**Resolution relating to a Certificate of
Appropriateness for constructing a
new two-story house with attached garage**

**at 100 W. Brown Street in the
Brewers Hill Historic District for Gregory
Baer & Robert Ater.**

Appeal of HPC Conditional Approval

PRELIMINARY SITE/FOUNDATION PLAN

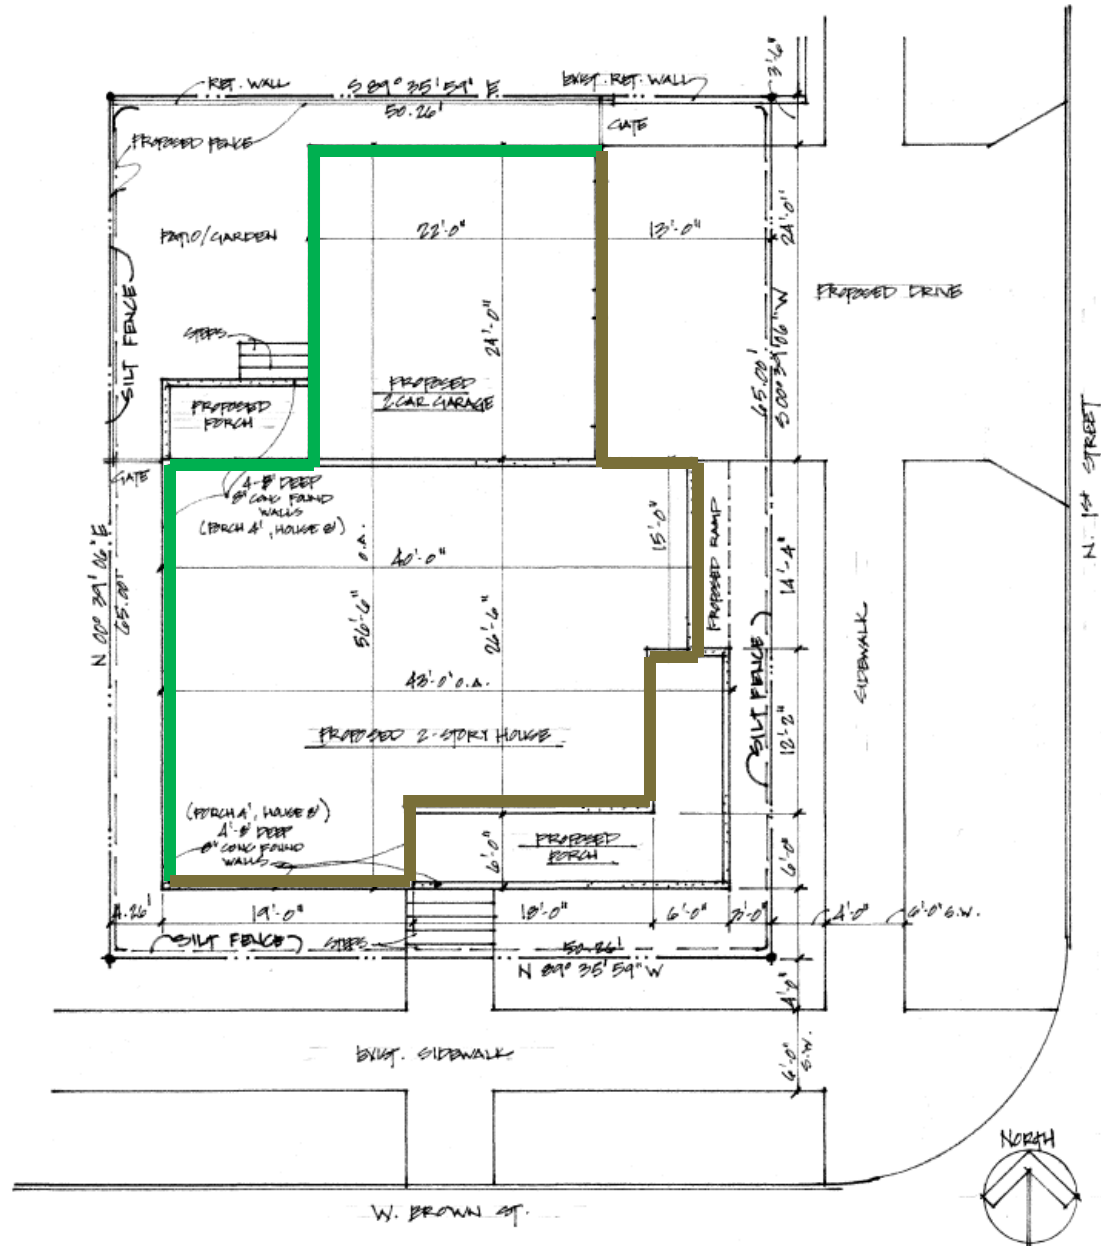
- Design approved as submitted

- Attached garage a major concession on this site already

- **Materials conditions:**

- Thick Hardie Artisan siding allowed on secondary elevations
- Wood for street elevations and all trim
- Wood windows rather than aluminum clad
- Composite decking for rear porch, wood for front

Wood Required

HardiePlank Allowed

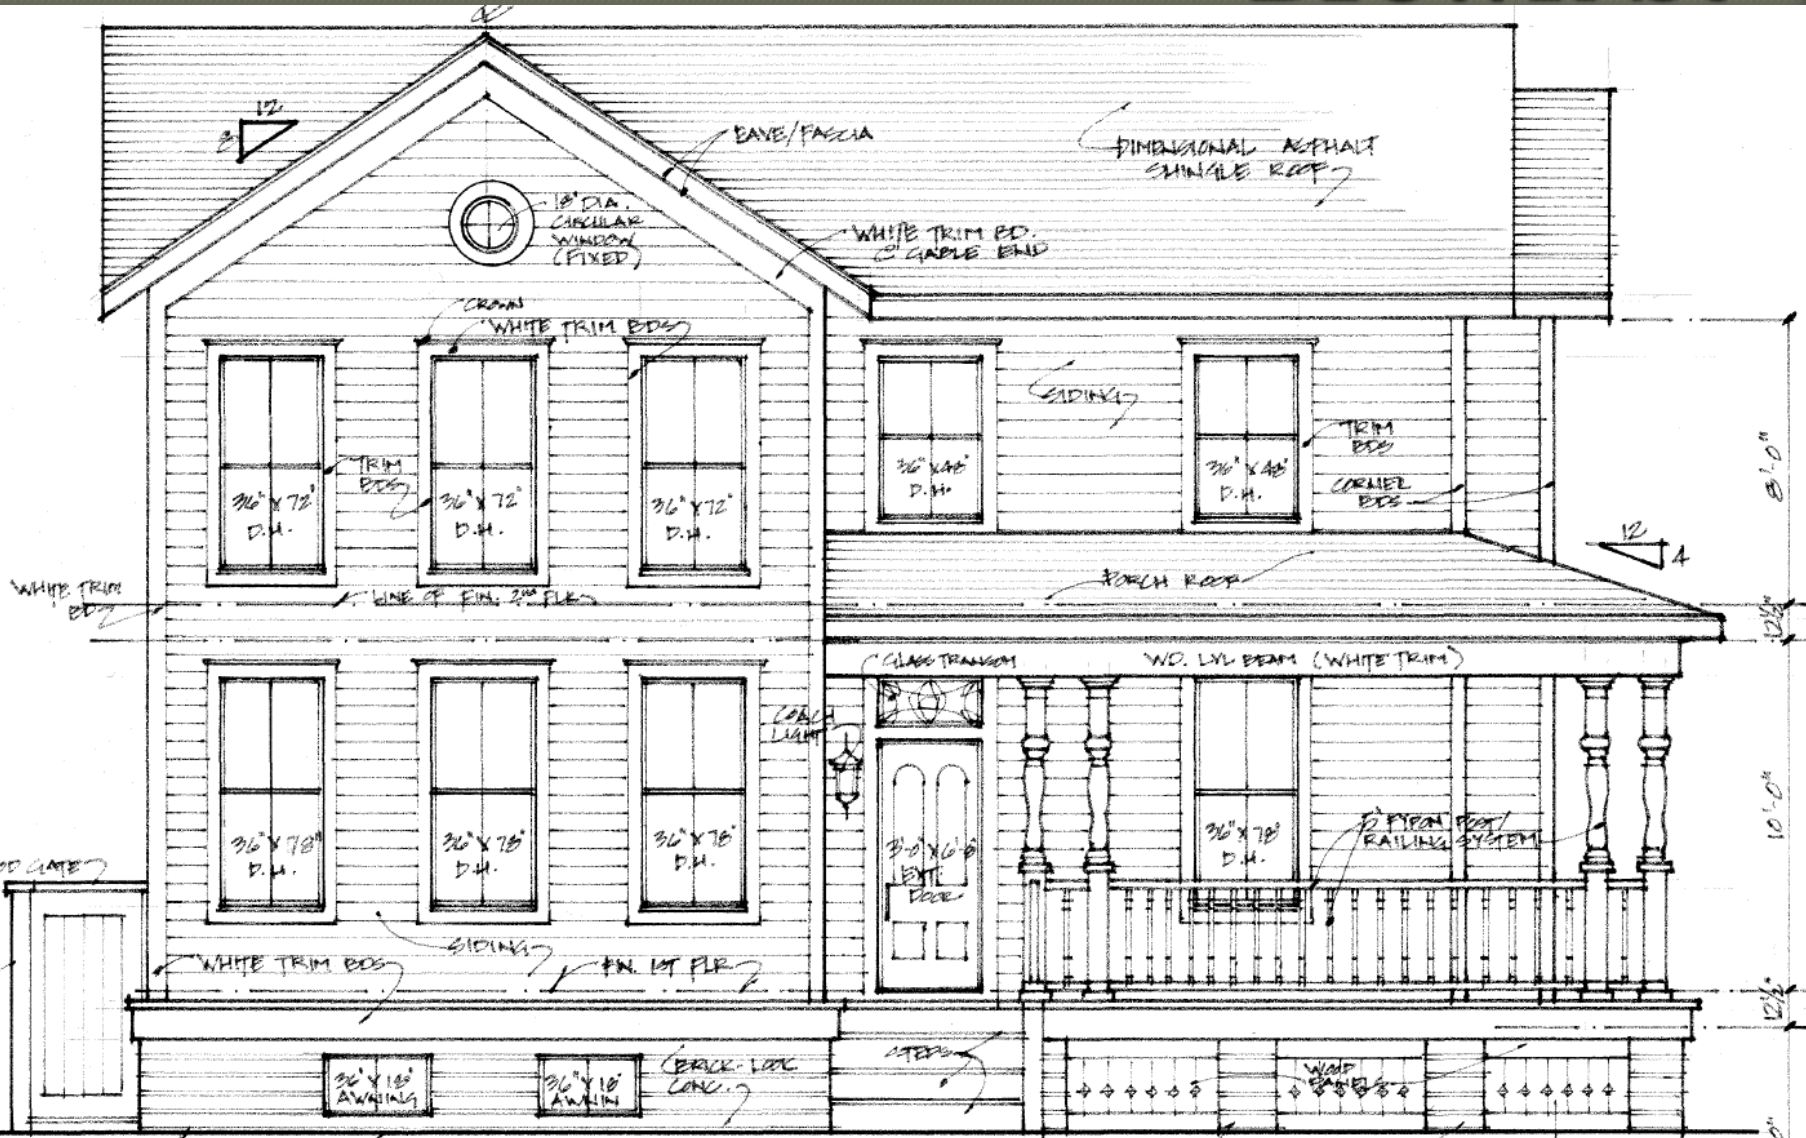
Street-facing, wood required

ATER-BAER WOOD PORCH POST/RAILING DET.
1/2" x 1'-0"

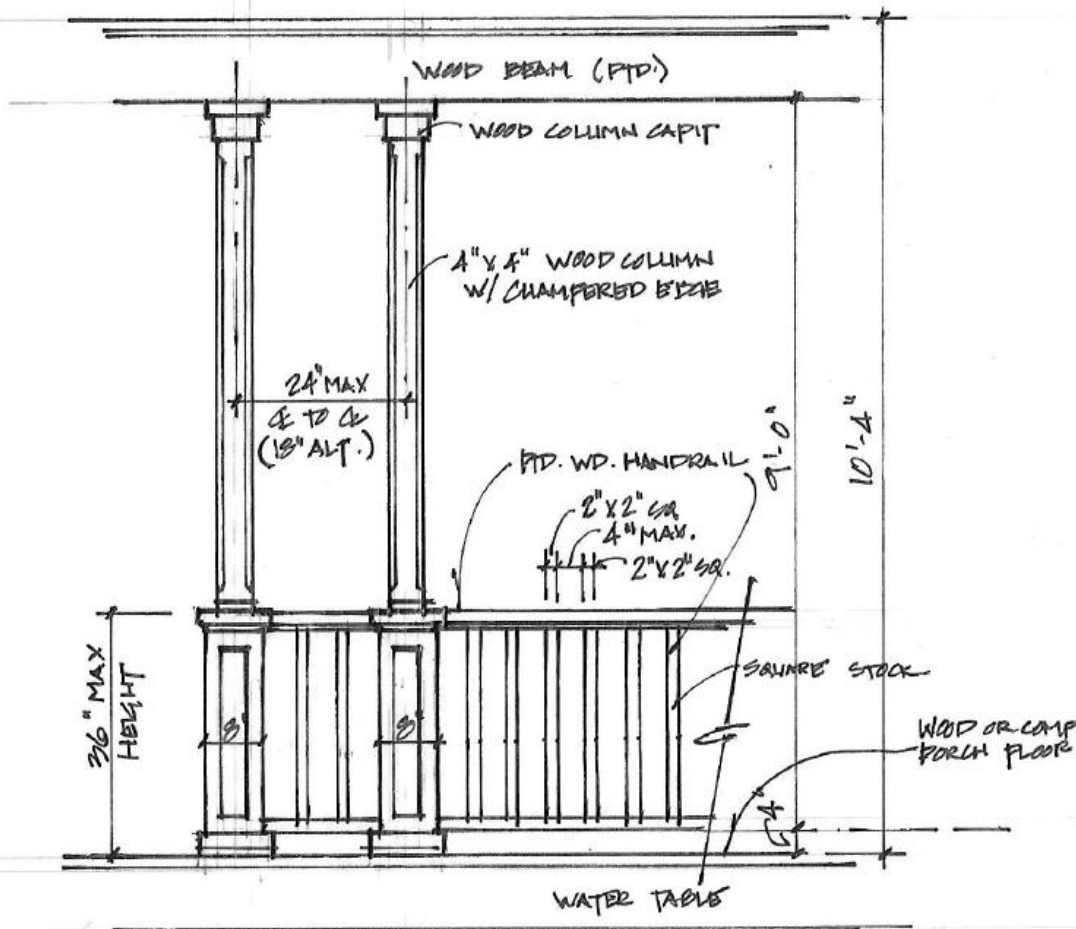
Revised porch

Rear/North

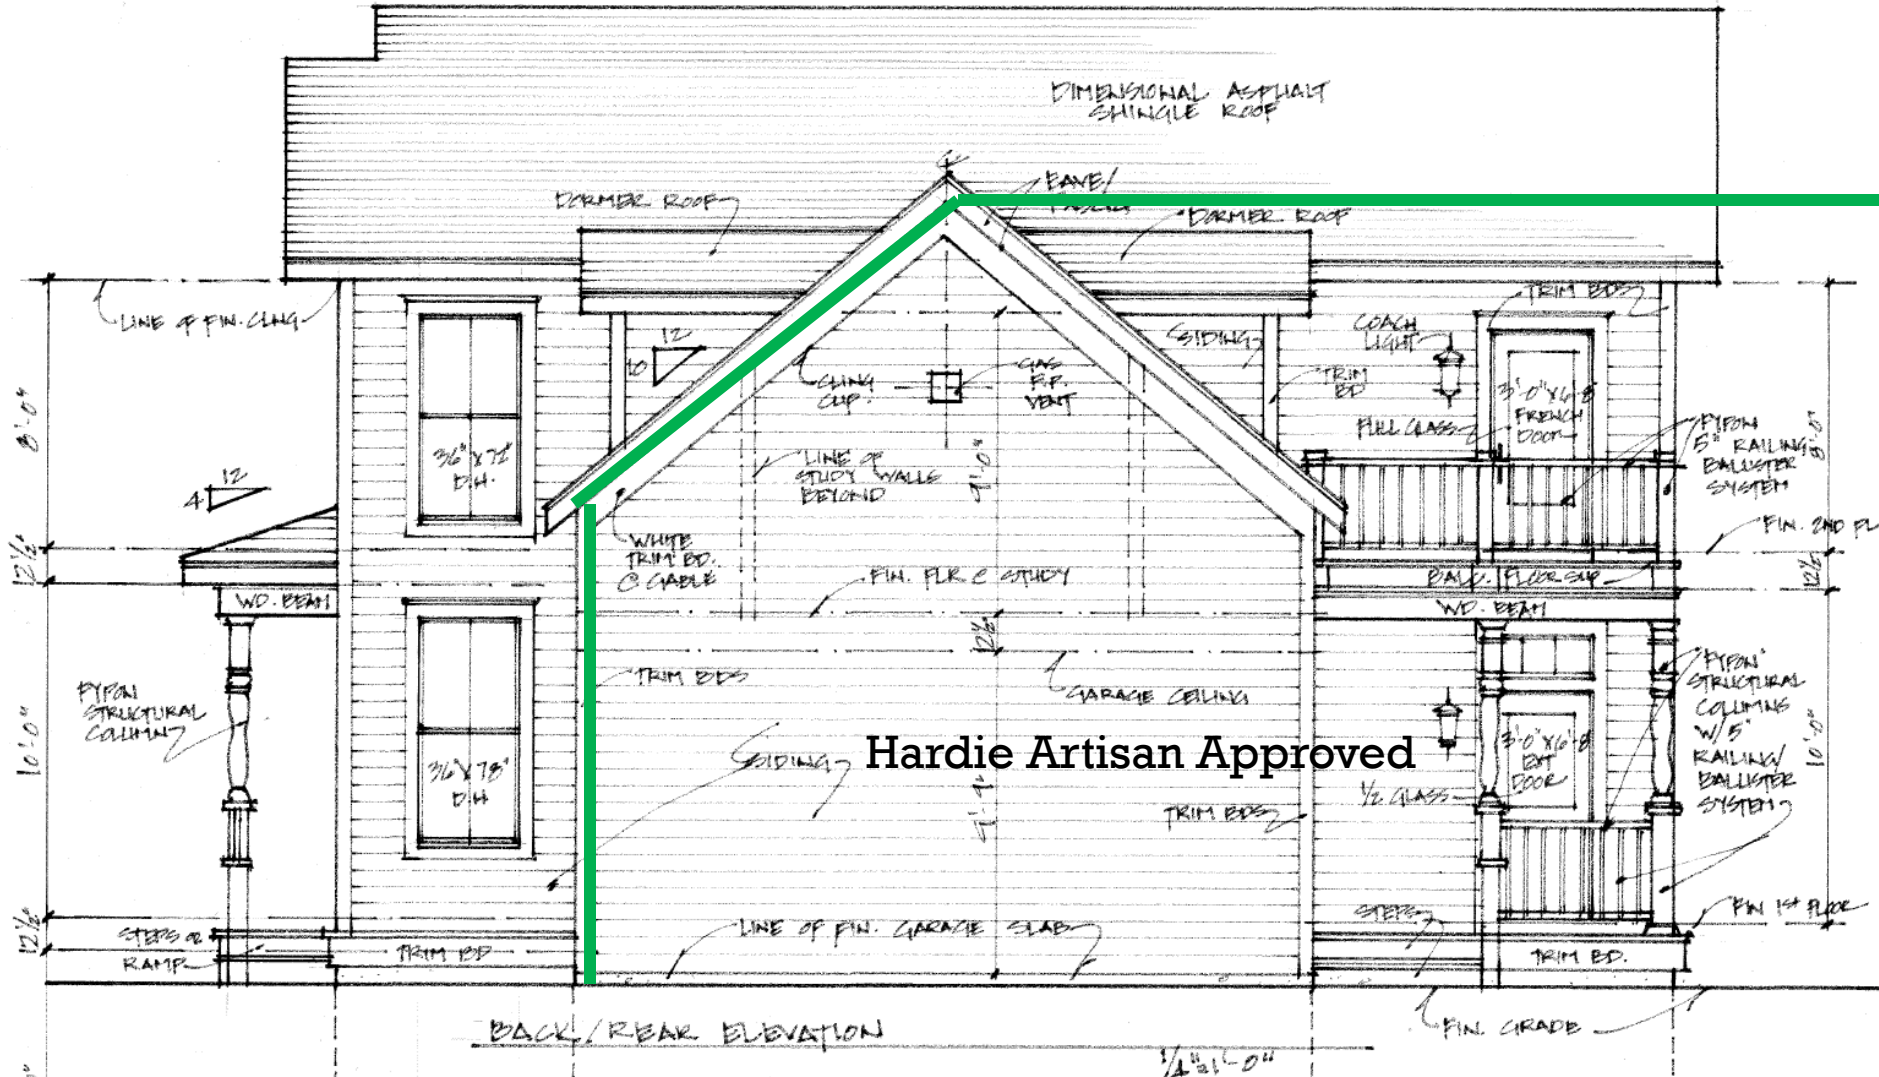
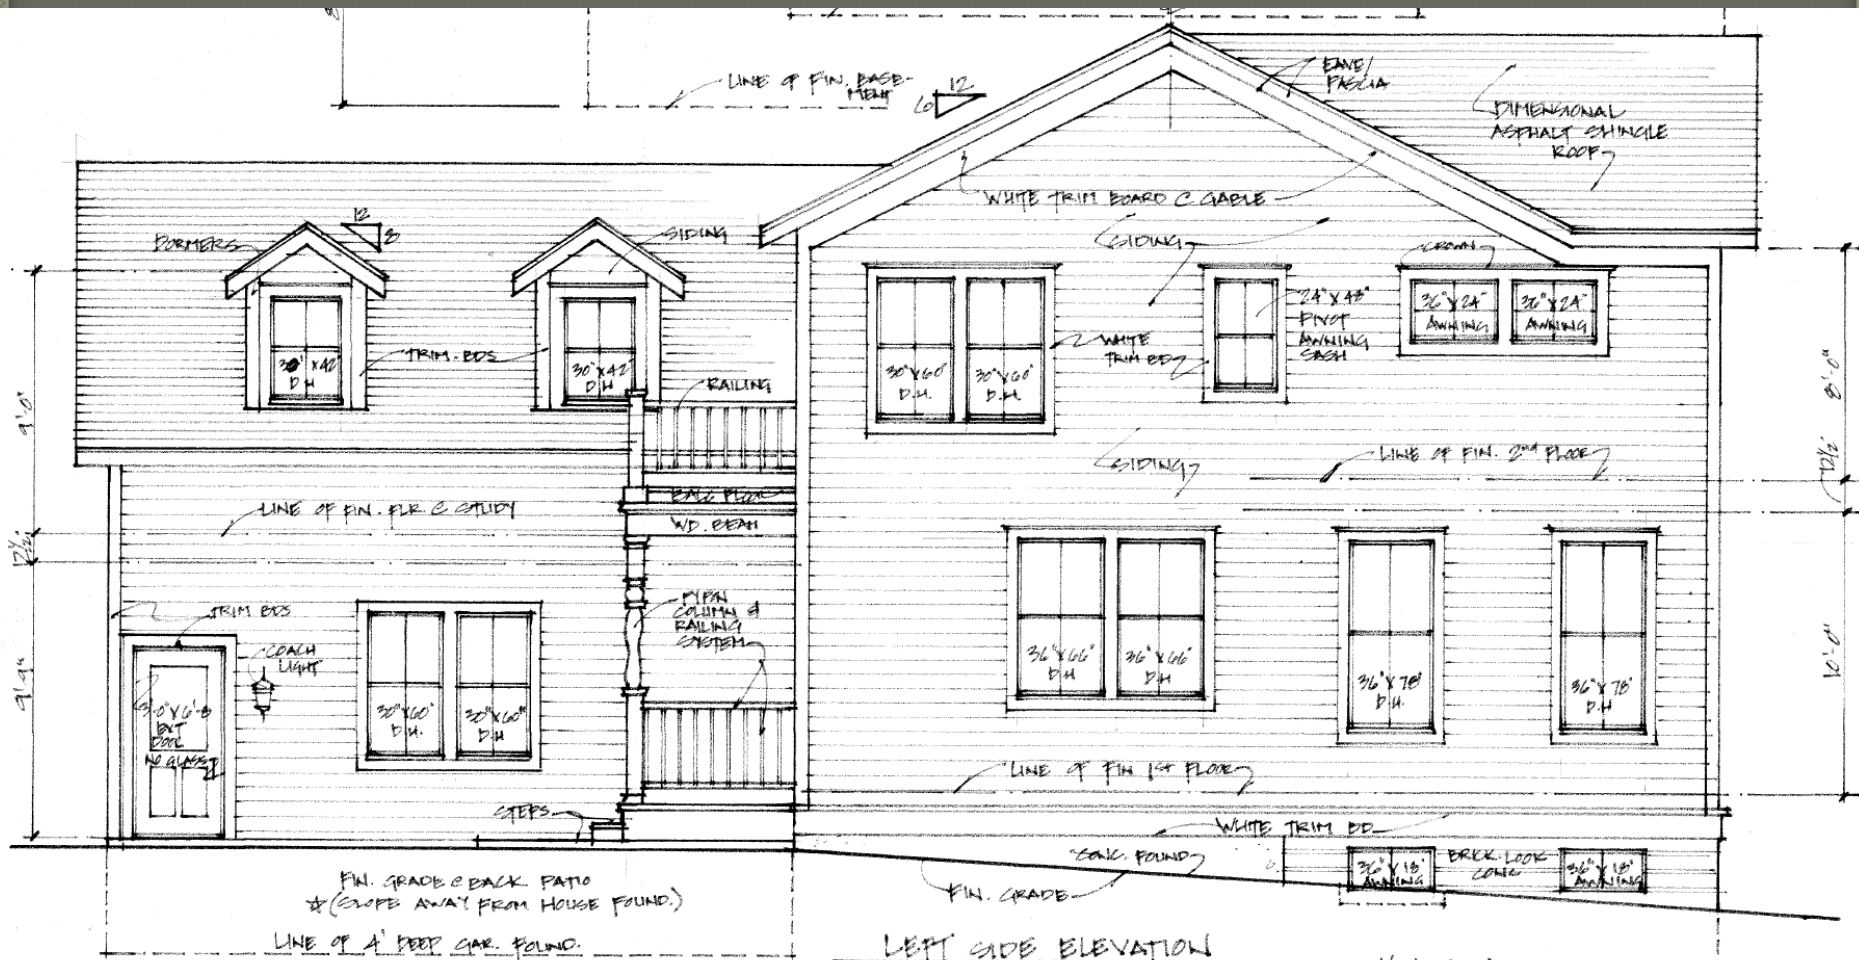
Hardie Artisan approved for this entire side of building.

FIGURE 1

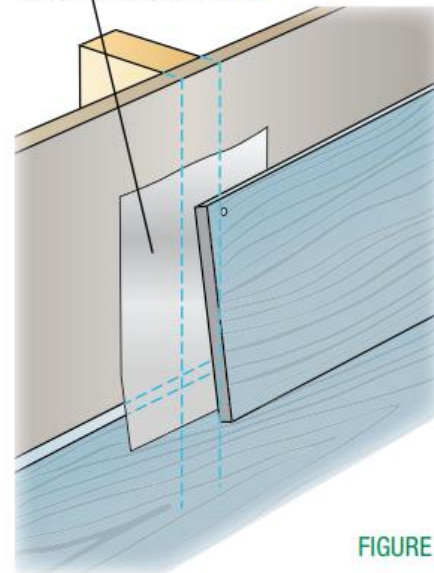
Considerable cost factor now that the manufacturer requires every joint to be flashed rather than caulked.

This is a requirement of warranty and leaves a visible gap between boards that is not indicated in the diagram.

James Hardie recommends 6 inch (152.4 mm) wide joint flashing that overlaps the course below by 1 inch (25.4 mm). See Figure 1. Some local building codes may require different size flashing. Joint-flashing material must be durable, waterproof material that does not react with cement based products. Examples of suitable material include painted or coated coil stock and code compliant water-resistive barriers, such as HardieWrap® weather barrier. Other products may also be suitable.
